CONSTRUCTION DRAWINGS FOR REX ROAD AT FALCON REGIONAL PARK IMPROVEMENT PLANS

REX ROAD
 AT FALCON REGIONAL PARK
 STREET AND UTILITY PLANS
 COVER SHEET

COUNTY PLAN REVIEW IS PROVIDED ONLY FOR GENERAL CONFORMANCE WITH COUNTY DESIGN CRITERIA. THE COUNTY IS NOT RESPONSIBLE FOR THE ACCURACY AND ADEQUACY OF THE DESIGN, DIMENSIONS, AND/OR ELEVATIONS WHICH SHALL BE CONFIRMED AT THE JOB SITE. THE COUNTY THROUGH THE APPROVAL OF THIS DOCUMENT ASSUMES NO RESPONSIBILITY FOR COMPLETENESS AND/OR ACCURACY OF THIS DOCUMENT.

REX ROAD, TEMP. MINOR ARTERIAL
STA 88+55.21 TO 89+50.16

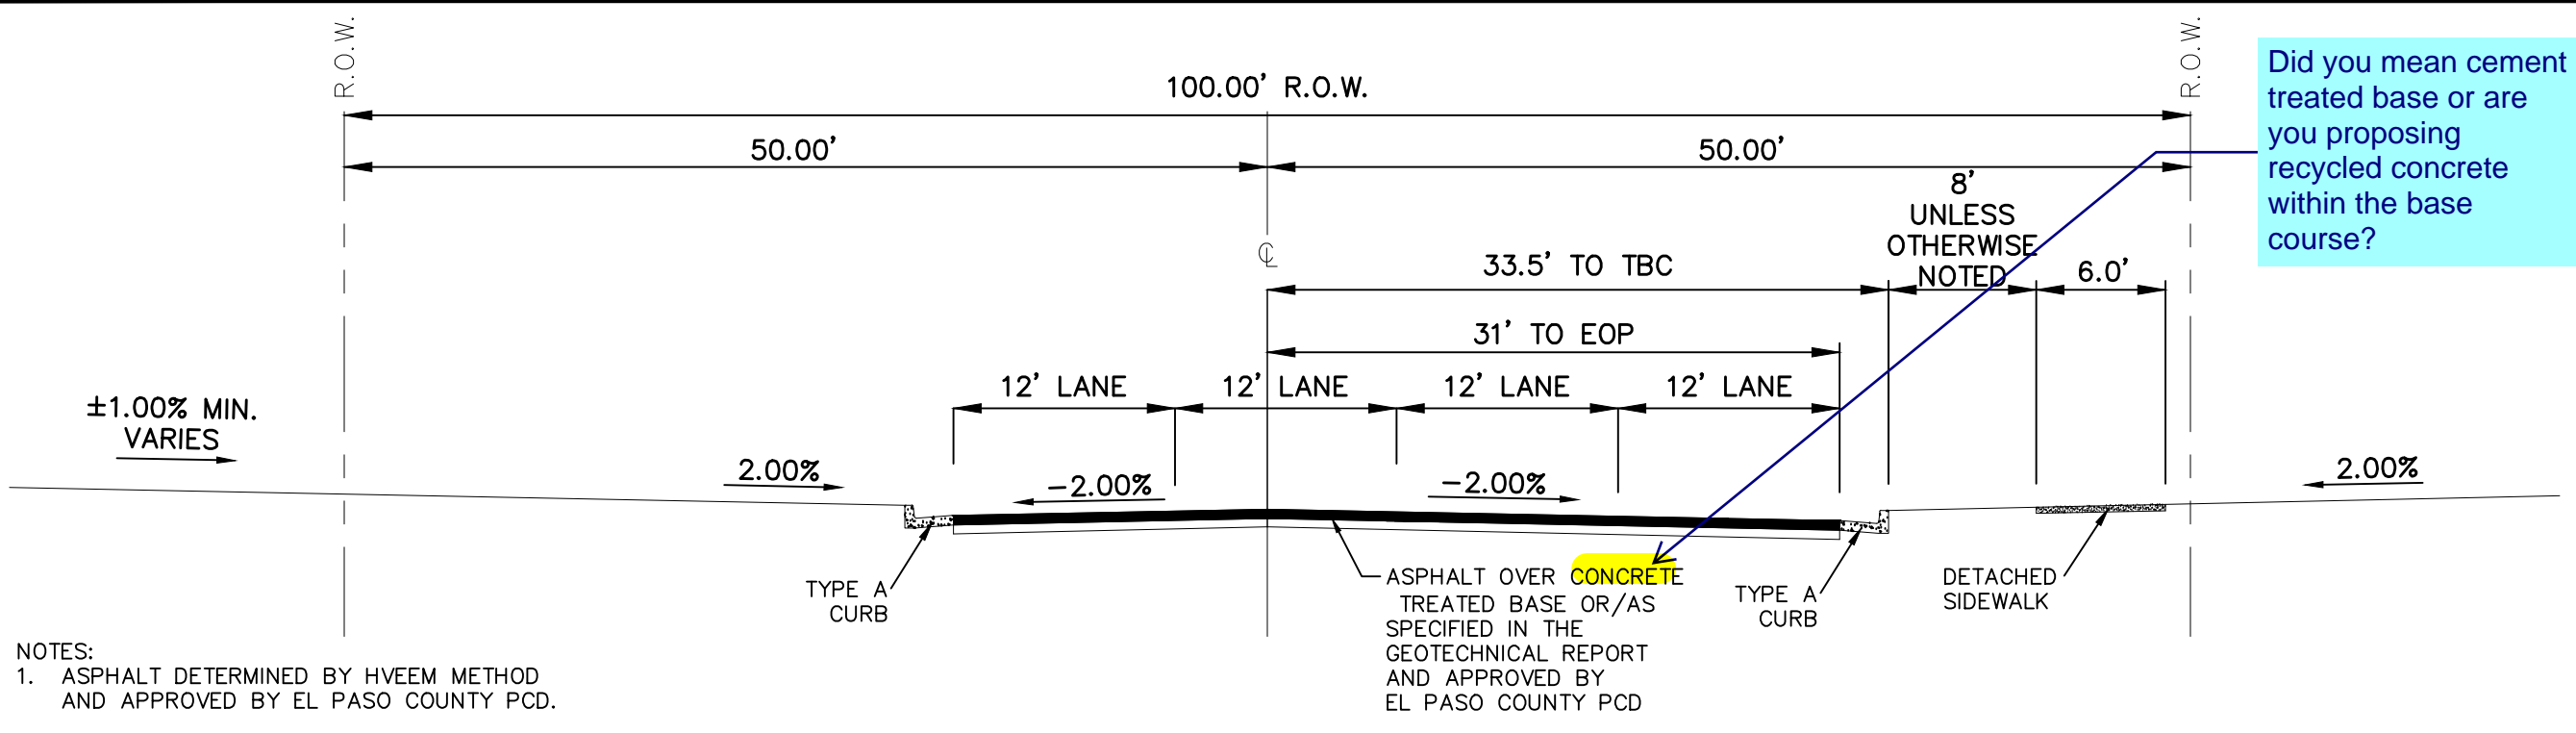
Did you mean cement treated base or are you proposing recycled concrete within the base course?

REX ROAD
AT FALCON REGIONAL PARK
STREET AND UTILITY PLANS
REX ROAD

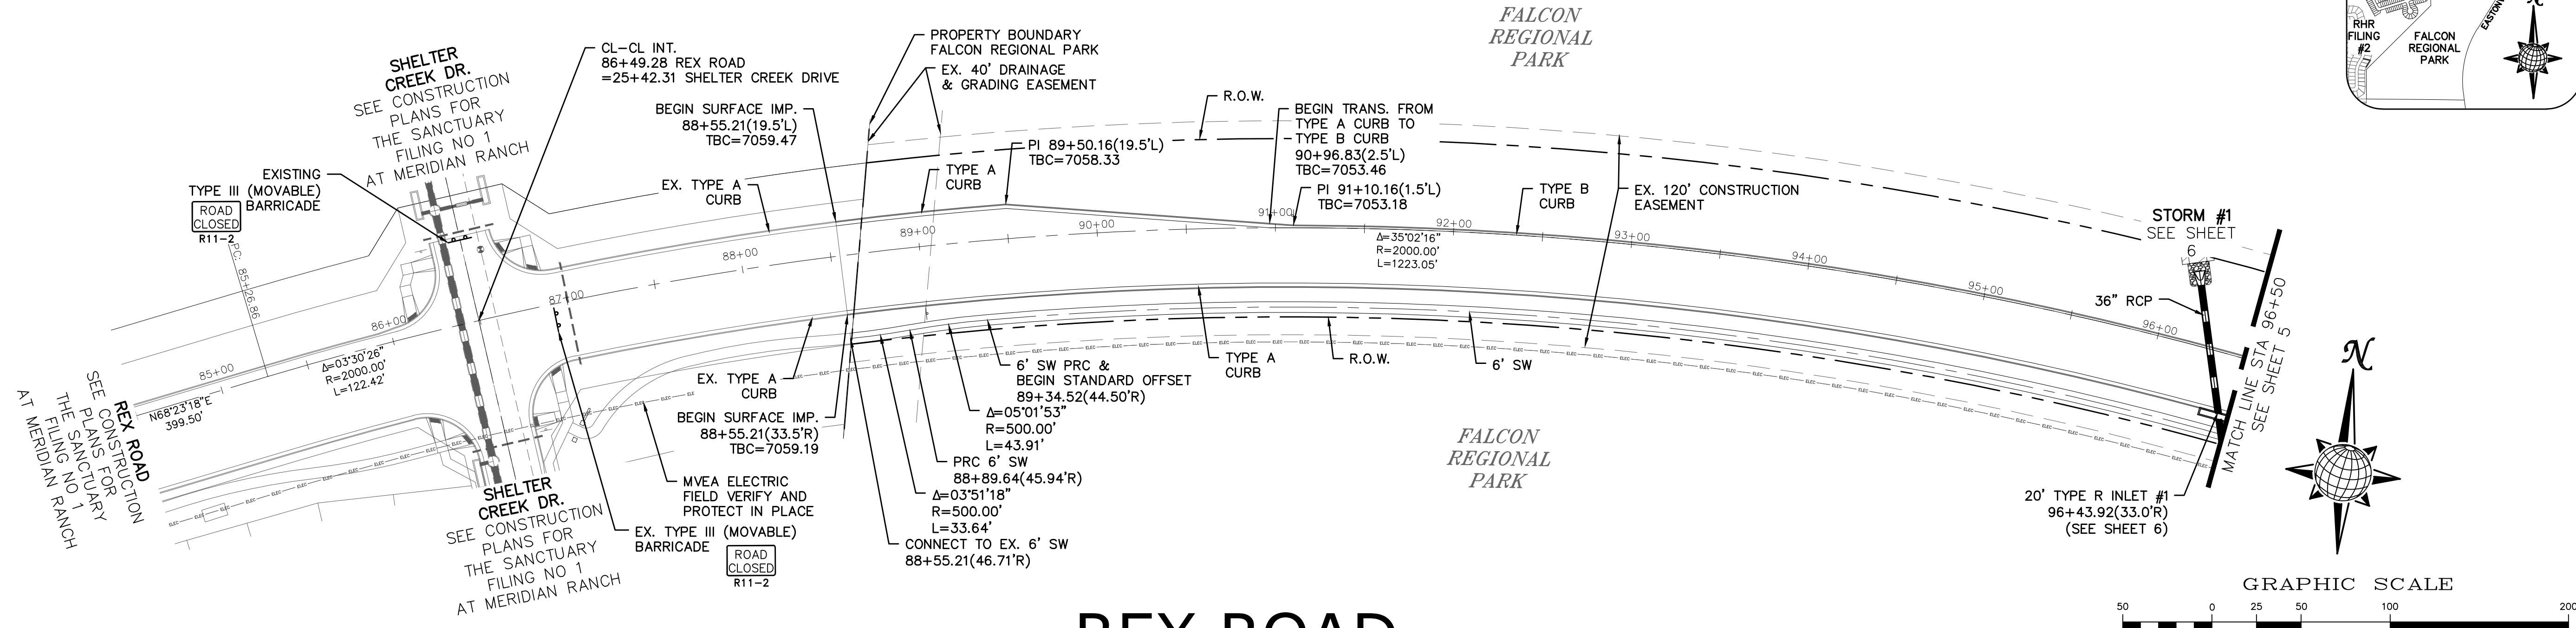
FYI: reimbursement/credit from sta 10+00 to the east will need to be verified as a half section of the minor arterial is not being construction.

Coordinate with Parks to ensure that the proposed radius is sufficient for their maintenance vehicles

what was the purpose of this pad and will removing it cause erosion issues?

Storm #1	OS-1	PIPE OUTLET	L	W	d	TYPE	D ₉₀	CY	NOTES
		36"	12.0	12.0	1.5	M	1.00'	19.0	SEE BELOW

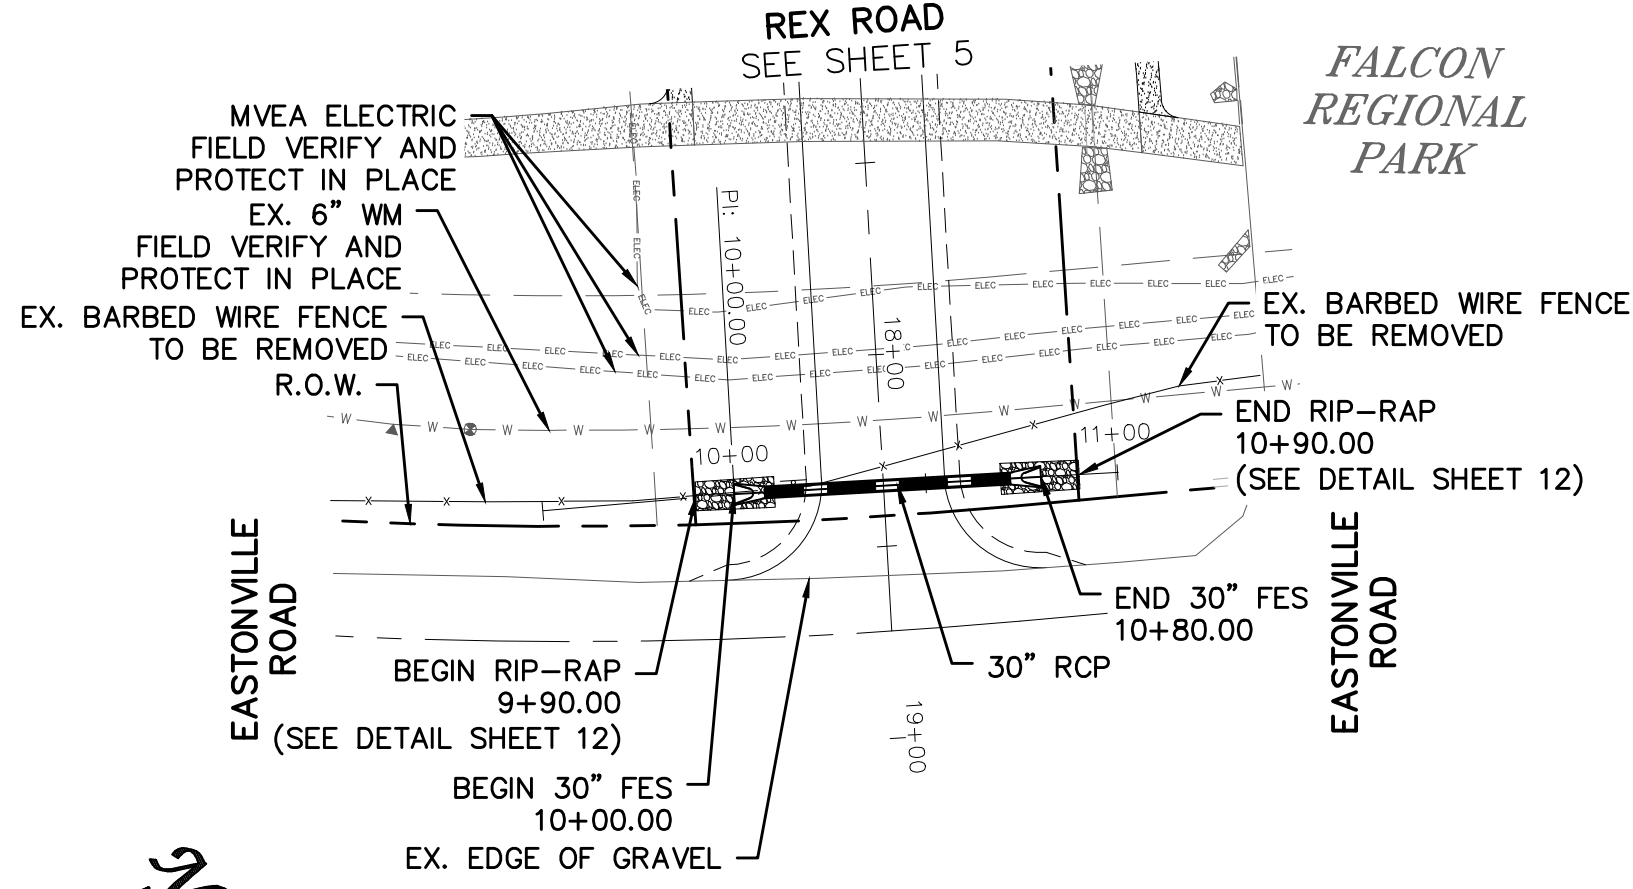
move detail to another sheet and enlarge so that it is legible in the field. Revise Sheet references accordingly.

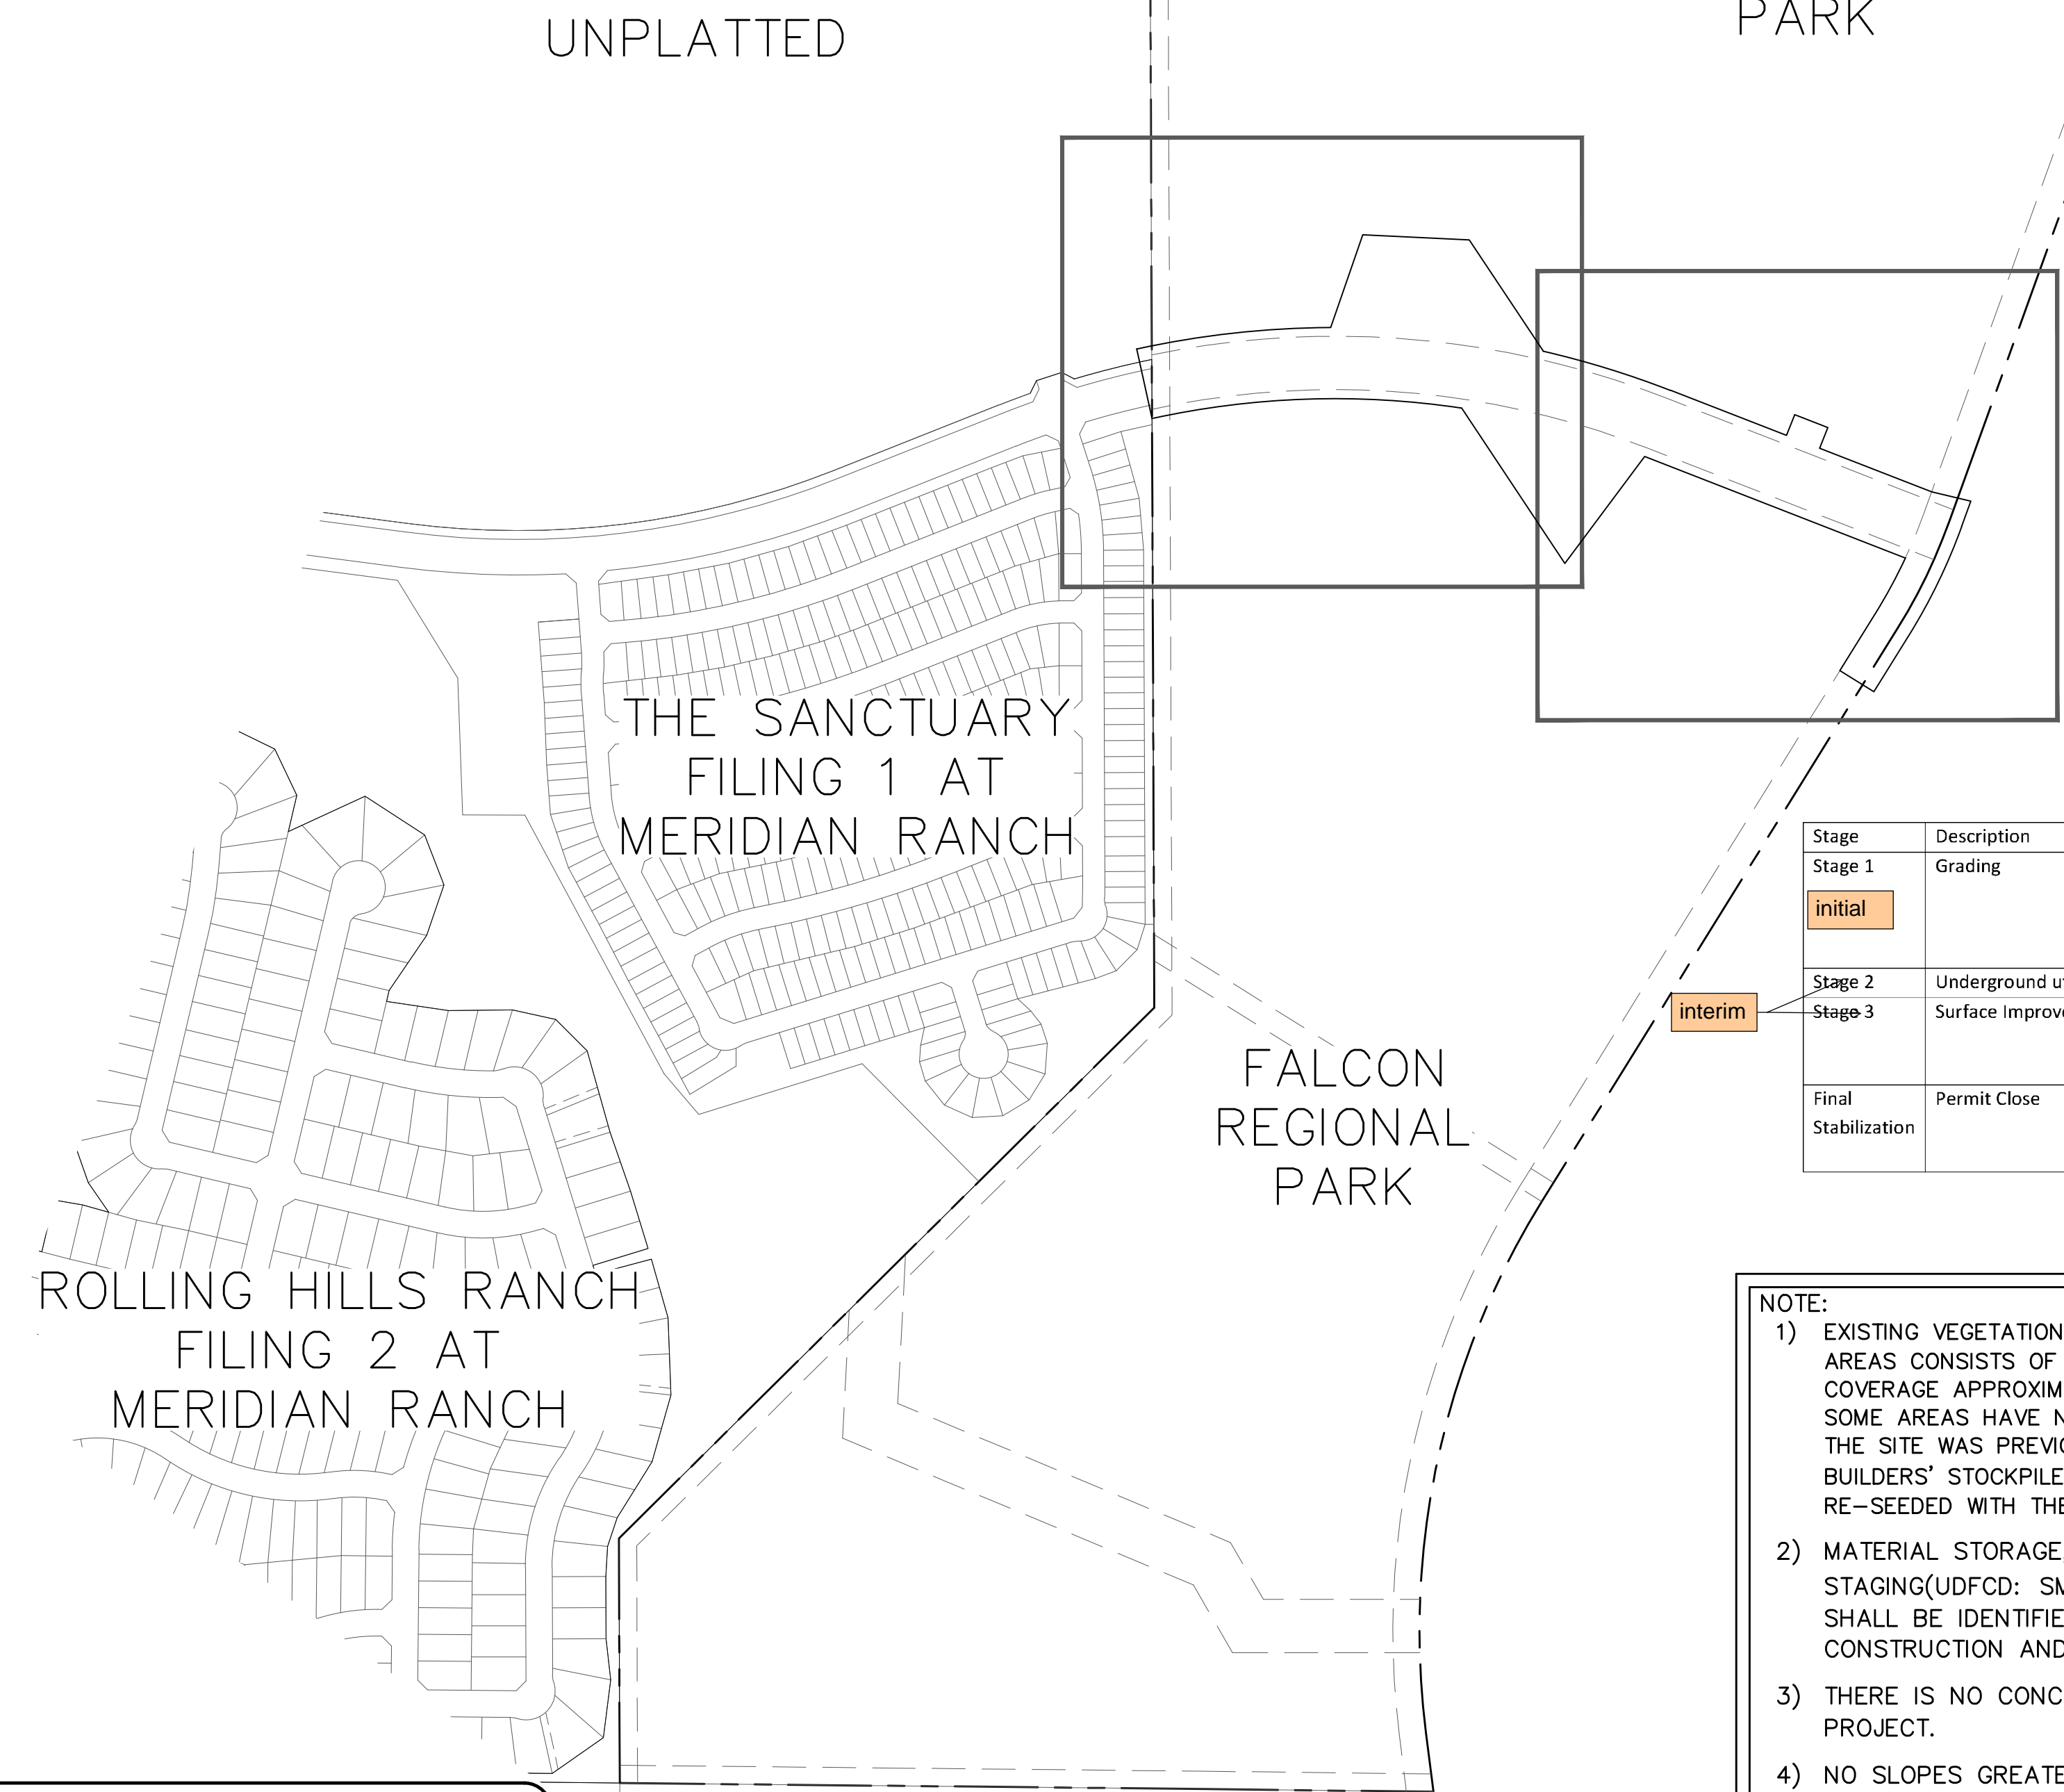
Please include date of report
